Pre-application presentation

| Reference | PF/20/00122 |
| Site | Royal Mint Court, London, EC3N 4QN |
| Proposal | Redevelopment of the site involving change of use from an existing office development (B1 use) to provide for a new embassy (sui generis use). |

Figure 1: Proposed layout (arrow pointing north)

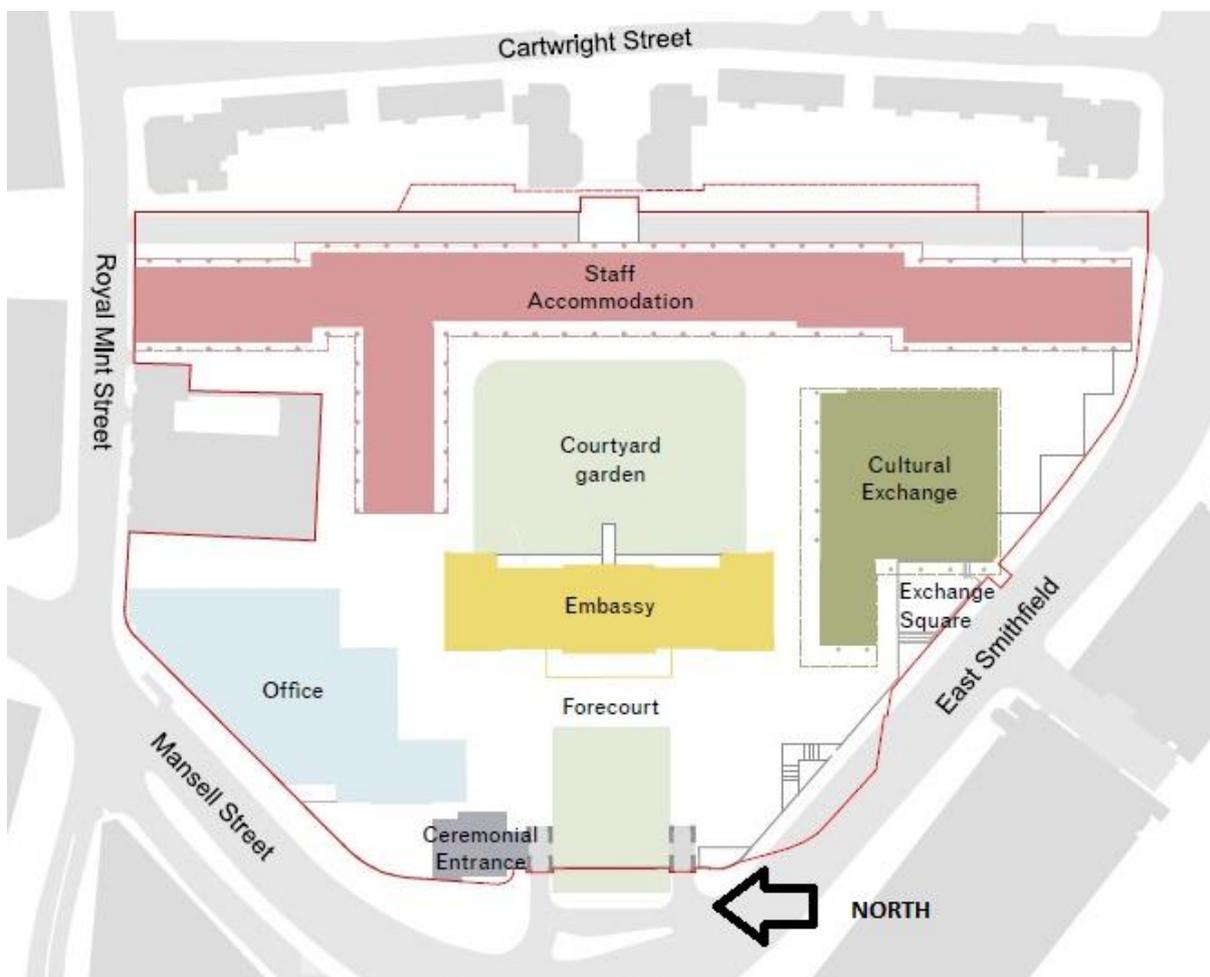
- 2.2 The proposed development (see Figure 1 above) would consist of; the principal embassy function occupying the Grade II* listed Johnson Smirke building fronted by a private forecourt and ceremonial entrance set towards the Tower of London; office spaces within a renovated and redeveloped Grade II listed former Seaman's Registry building; a described cultural exchange building for events with a visa processing function in the foot of the building that would open off a new small public space on East Smithfield Street identified as Exchange Square. Towards the rear of the site would be a long and linear building providing the main massing, serving as embassy staff residential accommodation containing 230 individual residential flats with a private courtyard garden set before it across from the Johnson Smirke building.

Figure 3: Proposed Cultural Exchange building finished in green ceramic

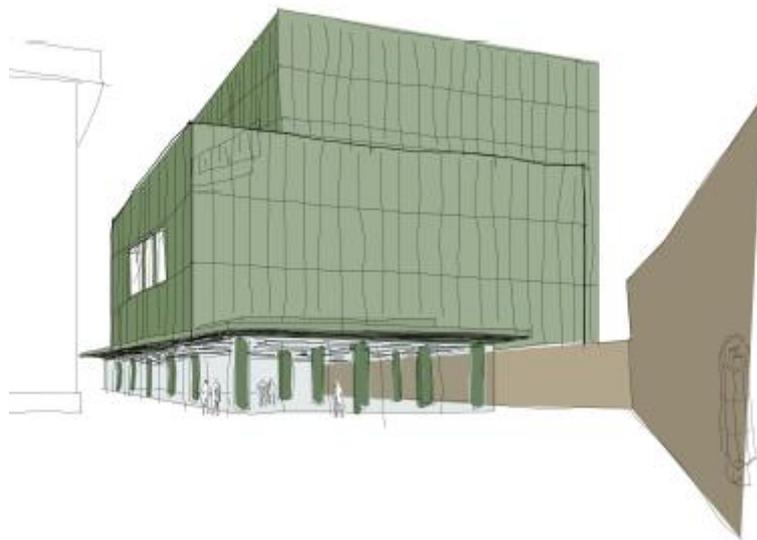
- 7.12 The proposed Cultural Exchange building has been designed as the most prominent new intervention for the site, separated from the existing Murray and Dexter House. Figure 3 above shows the latest iteration received recently which envisages a potentially extremely bold and striking green ceramic building. This would be prominent on East Smithfield and surrounding local views. Officers require high quality CGI visuals and significant further detail on the material and views in order to be able to support such a prominent proposal in this historical environment.

Image 14: Proposed archaeological offer

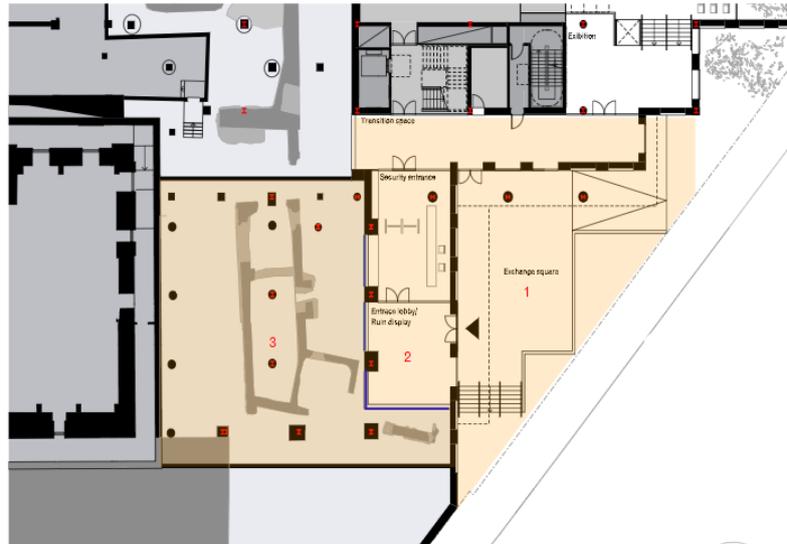
- 7.19 Considering the significance and extent of archaeological remains on-site, the proposals are not considered to sufficiently enhance or better reveal the heritage assets at present. Previous consents in 1986 and 2017 included provisions for public access, exhibition and interpretation space on-site. The current proposals provide minimal provisions for public views or access to the history or rich archive of the site.
